1. Type of Well Ø Oil Well Gas Well Other					8. Well Name and No. EMPIRE ABO I 20	
2. Name of Operator APACHE CORPORATION Contact: ISABEL HUDSON E-Mail: Isabel.Hudson@apachecorp.com					9. API Well No. 30-015-01215-00-S1	
3a. Address 3b. Phone 303 VETERANS AIRPARK LANE SUITE 3000 Ph: 432- MIDLAND, TX 79705 300			. (include area code) 8-1142			Exploratory

Empire ABO Unit # I-20 API # 30-015-01215 Eddy County, NM Surface Casing: 8-5/8" 24# Set @ 1,483' Production Casing: 4-1/2" 9.5# Set @ 6,114' Producing Interval: 5,783-6,064'

Objective: Isolate open perfs and TA wellbore

<u>Conditions of Approval</u> Apache Corporation Empire Abo Unit 1 - 20, API 3001501215 T18S-R27E, Sec 01, 667FNL & 666FEL November 29, 2016

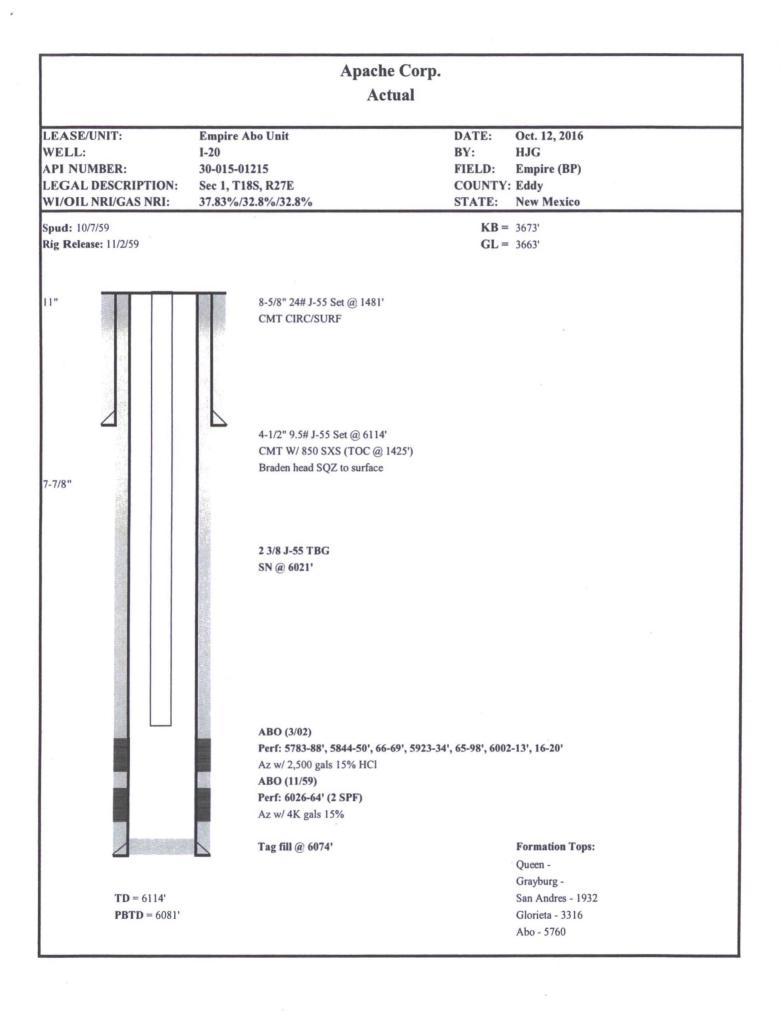
No record of the braden head squeeze claimed by the Apache wellbore diagram of 10/12/2016 has been found. Submit a dated record of that workover as a BLM sundry.
